**Economic Commission for Europe****Inland Transport Committee****World Forum for Harmonization of Vehicle Regulations****Working Party on Lighting and Light-Signalling****Eighty-eighth session**

**Simplification of Lighting and Light-Signalling UN Regulations****Revised proposal for a new [09] series of amendments to UN Regulation No. 48****Submitted by the Informal Working Group on Simplification of Lighting and Light-Signalling Regulations\***

The above limits and the initial aiming values are summarized in the diagram below.

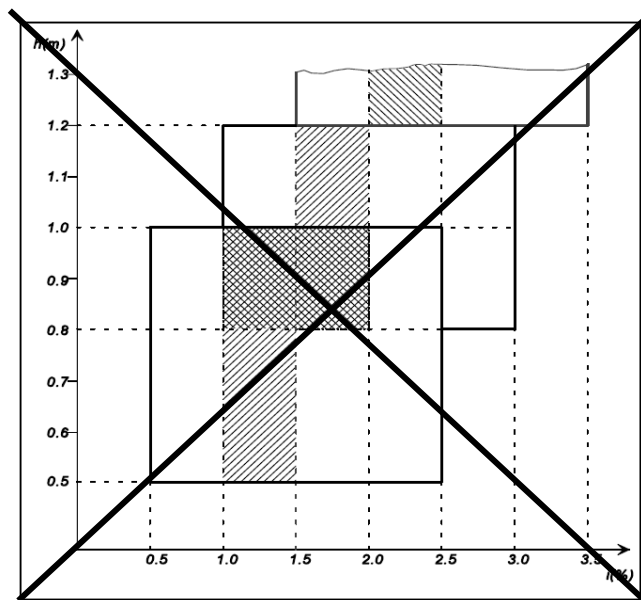
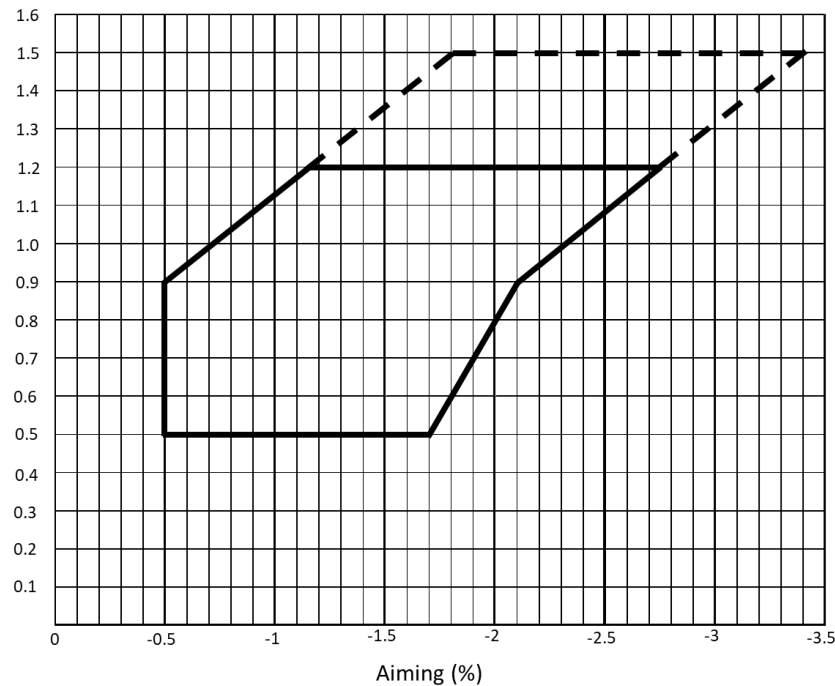
Depending on the mounting height in meters (h) of the lower edge of the apparent surface in the direction of the reference axis of the dipped-beam headlamp, measured on the unladen vehicles, the vertical inclination of the cut-off of the dipped-beam, **starting from the initial downward inclination value set by the vehicle manufacturer as prescribed in paragraph 6.2.6.1.1.**, shall ~~under all the static conditions of Annex 5, remain between the following limits and the initial aiming shall have the following values:~~, **under all the static loading conditions of Annex 5:**

Mounting height $h$ [m]	Upper inclination limit [per cent]	Lower inclination limit [per cent]
$0.5 \leq h \leq 0.9$	-0.50	$-(h + 1.2)$
$0.9 < h \leq 1.2$	$-(h \times 2.17 - 1.45)$	$-(h \times 2.17 + 0.15)$
$1.2 < h \leq 1.5$

**The area within the dashed line indicates the extension of the aiming diagram only valid for M<sub>2</sub>G, M<sub>3</sub>G, N<sub>2</sub>G, N<sub>3</sub>G (off-road) vehicles**

13. Paragraph 6.2.6.1.2. describes the new requirements for the vertical inclination limits of the cut-off, the provisions of which have been reorganised to improve readability. The vertical inclination values according to the installation height are presented in a table, by means of formula. A new diagram has been inserted providing an illustration of the requirements (aiming in per cent on the horizontal axis and headlamp mounting height in meters on the vertical axis).

15. The vertical line on the left was initially defined at 0 per cent and derived from the GTB study based on the "Klettwitz study" (informal document GRE-71-32). However, some Contracting Parties were reluctant to have the horizontal cut-off with no downward inclination. At its seventy-eighth session, GRE experts decided to keep the previous vertical limit of - 0.2 per cent. However, at its eighty-seventh session, in order to further mitigate potential glare, GRE finally agreed to set the vertical limit at - 0.5 per cent as indicated in the diagram below:

16. The inclined line on the left (starting from 0.9 m\* in height), initially resulted from a mathematical calculation based on the position of the oncoming driver's eyes (at 0.94 m high) for headlamps up to a height of 1.2 m, measured at a distance of 25 m and with an initial aim of 1 per cent down. Using this calculation, it is possible to increase the inclination proportionally to the installation height and still guarantee that glare remains under control; the cut-off line will always stay under 0.94 m at 25 m distance (for background information, see document VGL-10-03, sheet 13).

18. To cover all possible cases of a same type of vehicle (aiming tolerances / chassis deviation / cut-off-line stability / tyre deviation / full or empty tank / levelling device), a range of 1.6 per cent was agreed (see a survey of the International Organization of Motor Vehicle Manufacturers (OICA), document VGL-10-10) and used to define the right-hand limit and the point (-2.1 / 0.9), based on line defined in item 16.

19. Starting from 0.9 m high, the range of 1.6 per cent is applied to define the line on the right side of the diagram and up to 1.5m.

20. On the right side, under 0.9 m high, there was a compromise to reduce the range progressively to -1.7 per cent at a height of 0.5 m.

**“The controls for the headlamp-levelling devices referred to in paragraph 6.2.6.2.2. of this Regulation**

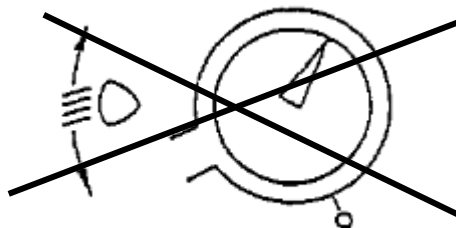
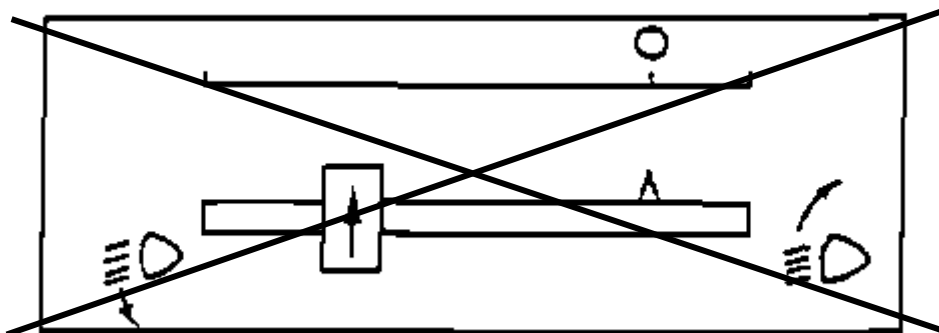
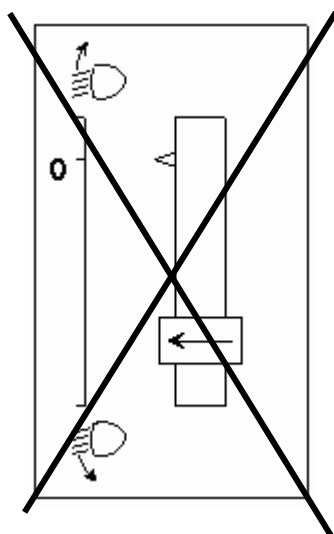
1. Specifications
- 1.1. ~~Downward~~Inclination of the dipped-beam shall in all cases be produced by a **simple control, the operation of which is clearly described in the owner’s handbook. in one of the following ways:**
  - (a) ~~by moving a control downwards or to the left;~~
  - (b) ~~by rotating a control in a counter clockwise direction;~~
  - (c) ~~by depressing a button (push pull control).~~

A rotary control that is installed edge on, or with only the edge visible, should follow the operating principles of control of types (a) or (c).
- 1.1.1. This control shall carry symbol(s) indicating clearly the movements corresponding to the downward and upward inclination of the dipped-beam.
- 1.2. The "0" position corresponds to the initial inclination according to paragraph 6.2.6.1.1. of this Regulation.
- 1.3. The "0" position which, according to paragraph 6.2.6.2.2. of this Regulation has to be a "stop position", need not necessarily be at the end of the scale.
- 1.4. ~~The marks used on control shall be explained in the owner's handbook.~~
- 1.5. ~~Only the following symbols may be used to identify the controls:~~

~~Symbols employing five lines instead of four may also be used~~

- ‘Downward’ should be deleted. In the old text it is referring to the direction of the control device. For trucks dipped-beams are adjusted both upwards and downwards, due to different loading characteristics of different vehicle configurations.
- In order for the requirements to be technology neutral, the prescriptions of control methods (downwards, rotary, push-pull) have been deleted.
- The requirement in para. 1.3., referring to the owner’s handbook, has been moved into the main regulatory text (see paragraph 6.2.6.2.2.) and therefore can be deleted.
- The requirement in para. 1.4., specifying the symbols that can be used, has been deleted as these are already prescribed in UN Regulation No. 121.
- Examples of controls 1, 2 and 3 have been deleted, as the illustrations are considered outdated.
